MEMO

Re: Appl. #PL2022-314 - PRELIMINARY DEVELOPMENT PLAN - Arborwalk West, 3640 SW Arboridge Rd;
Christie Development Associates, LLC, applicant

Figure 1. Updated Site Plan

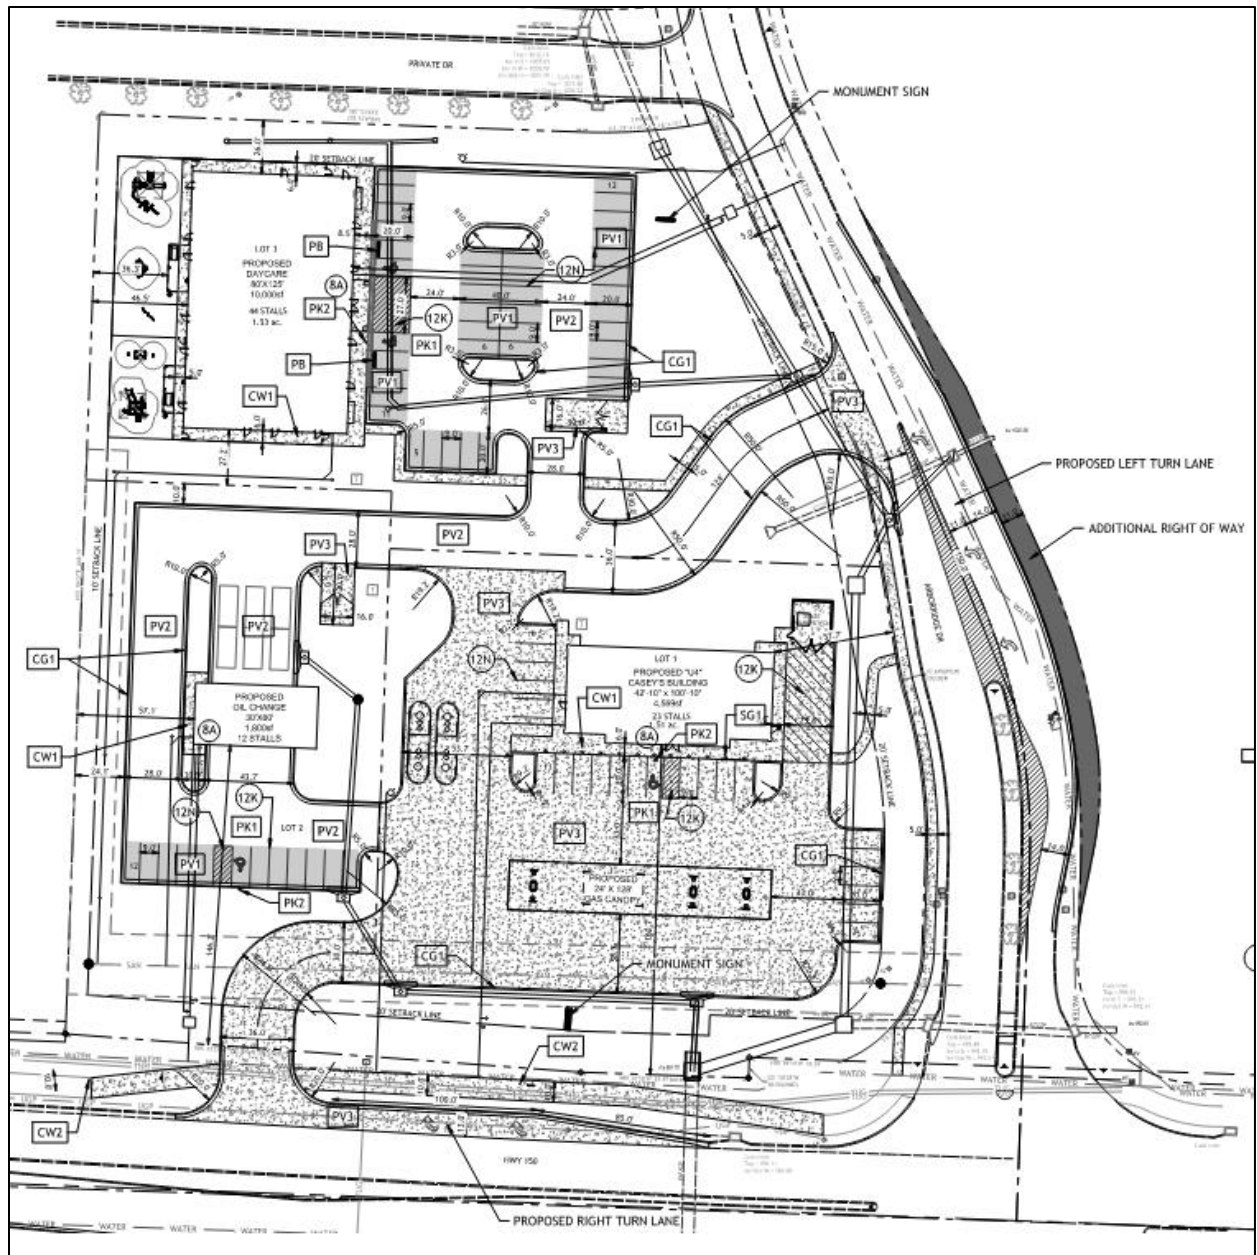
The applicant has stated that while it would be their preferred option to share access with the church, ultimately a shared access agreement could not be reached. In lieu of the shared access, the applicant has relocated the daycare's access to the south property line and will use the driveway from SW Arboridge Dr. that is being proposed to serve the other uses on the subject PDP.

The applicant reached out to the church leadership to discuss possibly moving the MO 150 access point after discussion regarding possible expansion the church had in the future. After those discussions, the applicant has chosen to leave the access point along MO 150 Highway as originally proposed. The location of the proposed access point meets all MDOT, Access Management and UDO requirements.

An updated traffic study was provided to ensure the new access location would meet all UDO requirements. After review of the update traffic study, the City Traffic Engineer has concluded that the new access configuration meets all Access Management and UDO requirements.
